**MFN 06-211**

### **Compilation of GE Responses to RAIs Related to NEDE-33173P**

**Non-Proprietary Version**

**Figure 2.2-1 Sensitivity of Cold Critical Eigenvalue to EPU Operation**

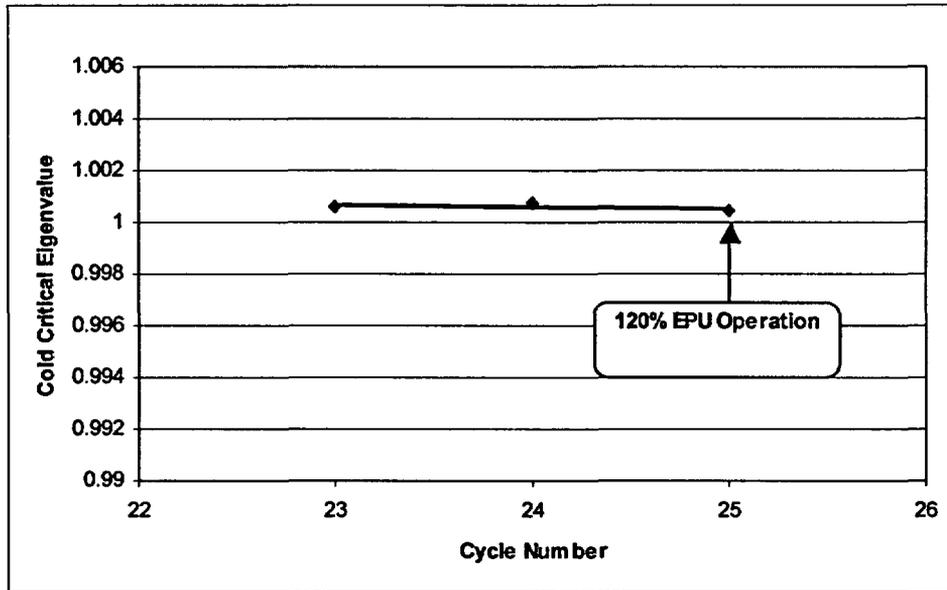
The LTR states that the same SDM Technical Specification value used for non-EPU core designs is adequate for EPU and expanded operating domain conditions. Provide the basis as to why cold SDM is not a strong function of the current operating strategies by comparing cold critical data before and after EPU. Include in the discussion the impact of core designs necessary to achieve EPU and maintain extended cycle lengths (e.g., larger batch fractions, higher bundle enrichments and different core loading patterns).

As a final demonstration of these concepts, the trending of the cold eigenvalues for a BWR/4 through a 120% EPU transition is provided in Figure 2.2-1. The scale of the data is consistent with that given in Figure 2-4 of NEDC-33173P. There is no identifiable aberration with the trend because of EPU.

Figure 4.1d-1 Regional Mode Instability Event and Test Decay Ratios:  
ODYSY Results vs. ODYSY Stability Criteria Map

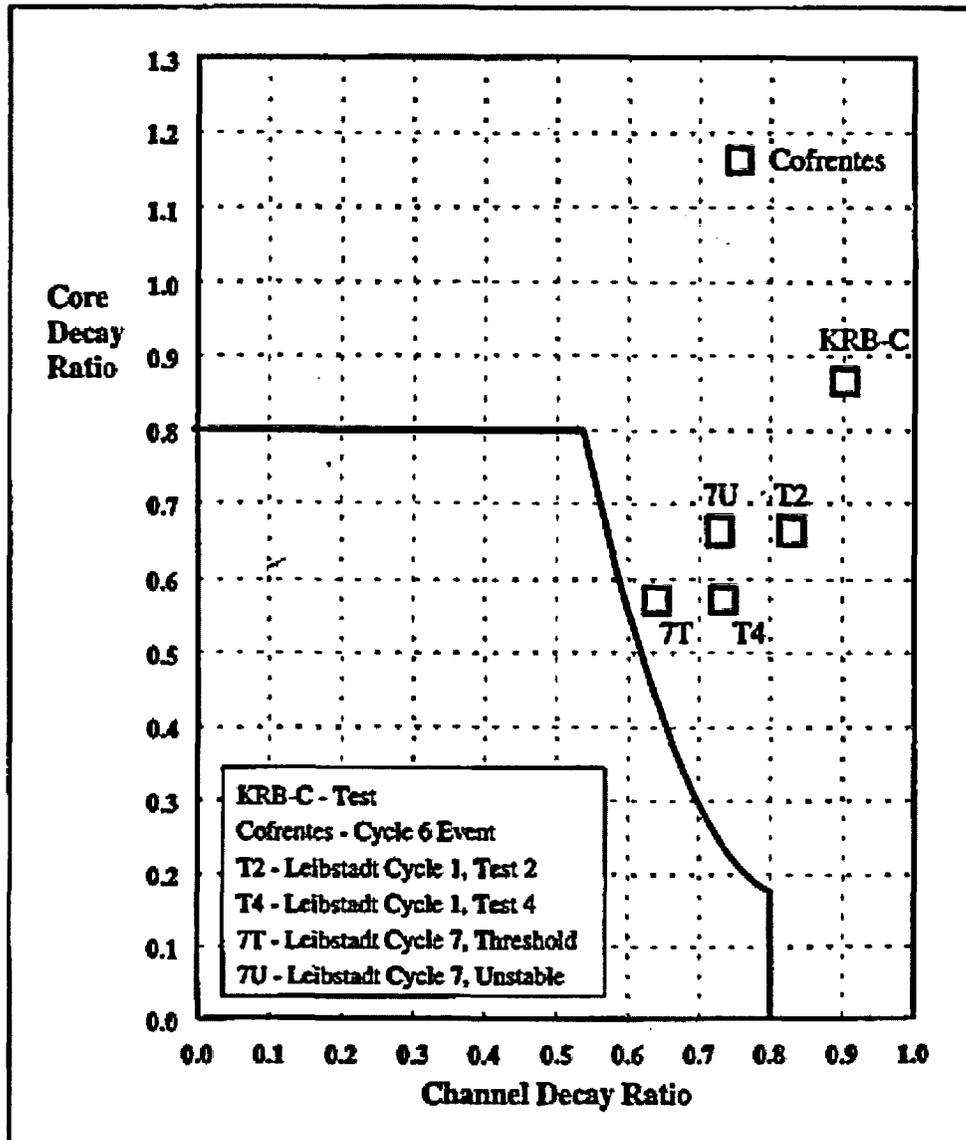
Provide and include the cited instability benchmarking that demonstrates the accuracy of ODYSY and TRACG in the TR. Provide some assessment of the similarities of core thermal-hydraulic conditions between the benchmark plants and the EPU plants.

Reference 4.1(d)-1 also provides ODYSY predicted core and limiting channel decay ratios for regional mode oscillations from tests at Leibstadt and KRB-C and the 1991 Cofrentes instability event. The ODYSY results are compared to the ODYSY stability criteria map in Figure 4.1d-1. Regional mode oscillations are possible when the limiting channel decay ratio exceeds the curved line that begins at 0.56. As can be seen in Figure 4.1d-1, the ODYSY predicted core and limiting channel decay ratios for the tests and instability event exceed the stability criteria. Therefore, the combination of the ODYSY calculated decay ratios and the ODYSY stability criteria map provide a good prediction for regional mode oscillations.
